JESMAR SUBDIVISION

APPLICATION NUMBER 5 DATE July 3, 2014

REQUEST Subdivision

DETAIL SITE PLAN

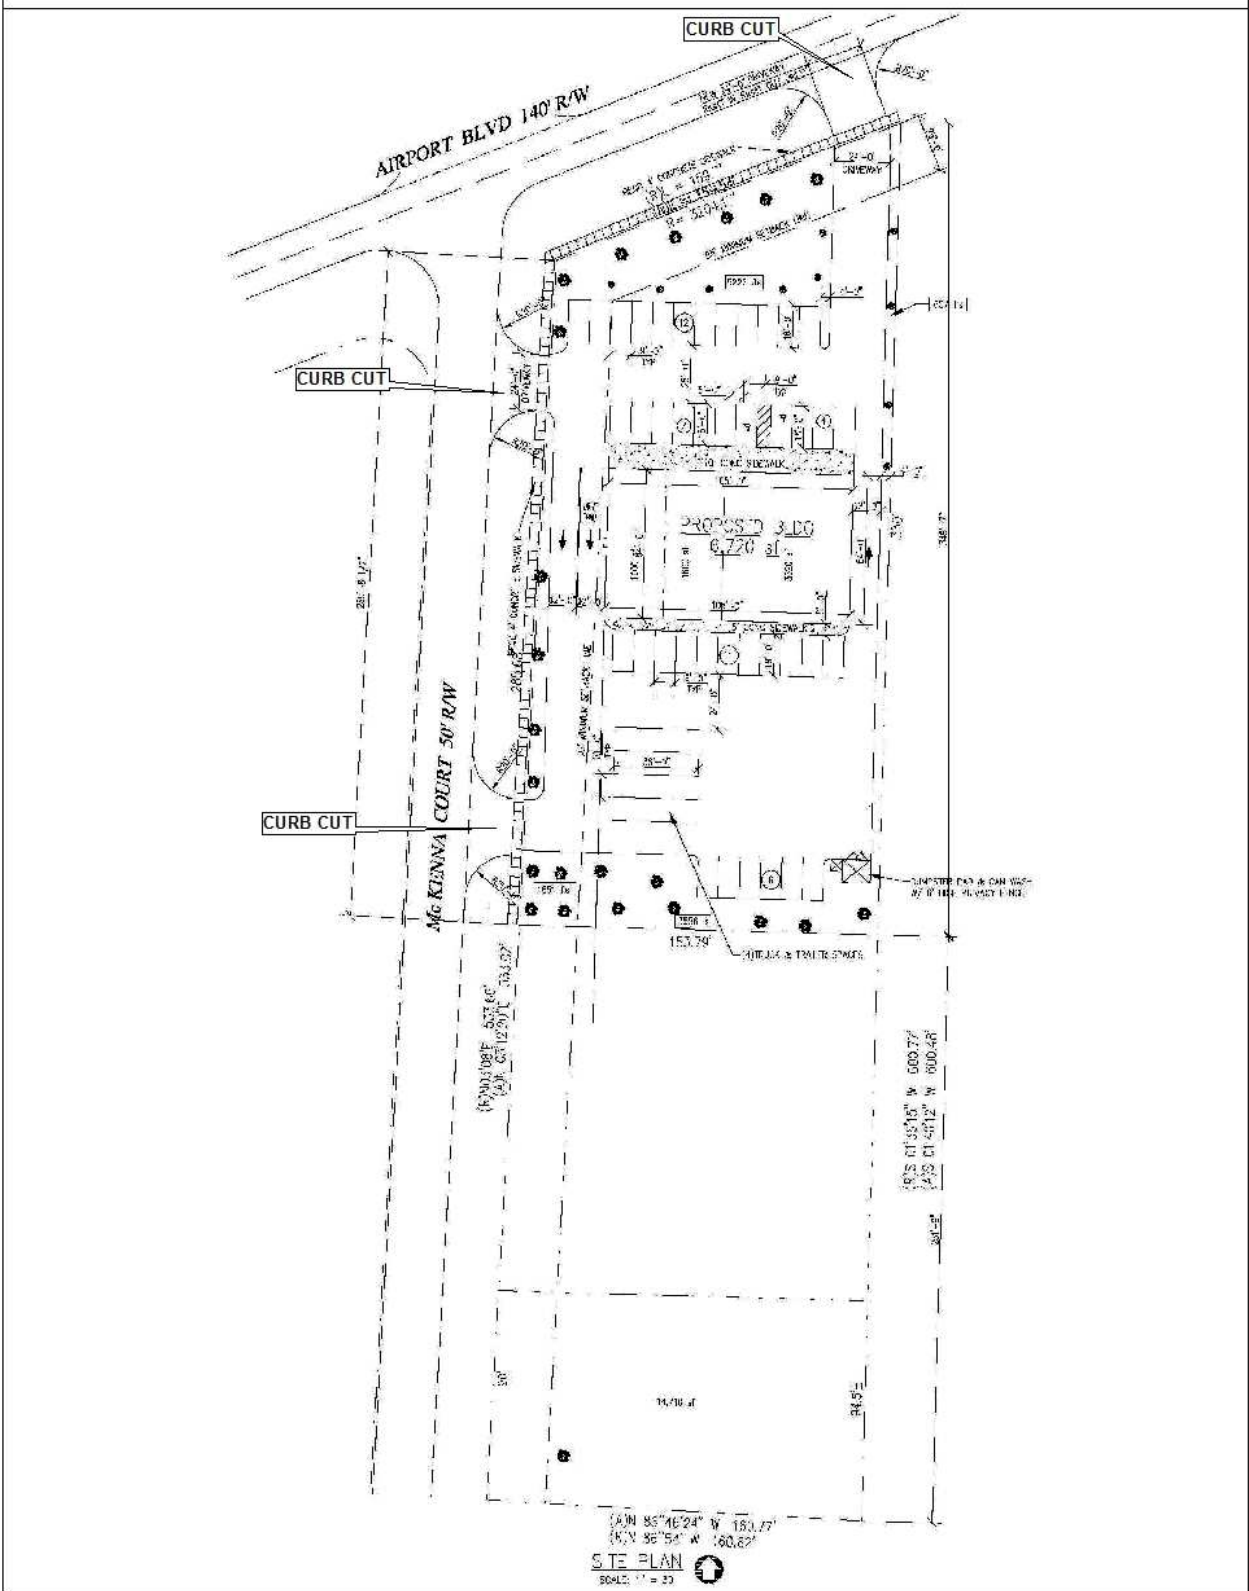
The applicant submitted a site plan for a proposed development depicting Lot 1 as having one curb cut to Airport Boulevard and two curb cuts to McKenna Court. However, Traffic Engineering recommends only one curb cut to McKenna Court for each lot and no access to Airport Boulevard. Therefore, as a means of access management, a note should be required on the Final Plat stating that each lot is limited to one curb cut to McKenna Court, with the size, location and design to be approved by Traffic Engineering and conform to AASHTO standards. A note should also be placed on the Final Plat stating that Lot 1 is denied access to Airport Boulevard.

The 25' minimum building setback line along McKenna Court and Airport Boulevard should be retained on the Final Plat. The plat should be revised to illustrate the minimum building setback line at the Southeast corner of Airport Boulevard and McKenna Court as measured from the required radius curve dedication. As on the preliminary plat, the lots should be labeled on the Final Plat with their size in square feet and acres, after all required dedications, or a table should be furnished on the Final Plat providing the same information.

- 1) dedication of a 25' radius curve at the Southeast corner of Airport Boulevard and McKenna Court;
- 2) placement of a note on the Final Plat stating that each lot is limited to one curb cut to McKenna Court, with the size, location and design to be approved by Traffic Engineering and conform to AASHTO standards;

- 3) placement of a note on the Final Plat stating that Lot 1 is denied access to Airport Boulevard;
- 4) retention of the 25' minimum building setback line along McKenna Court and Airport Boulevard;

- 5) revision of the minimum building setback line at the Southeast corner of Airport Boulevard and McKenna Court to be measured from the required radius curve dedication;
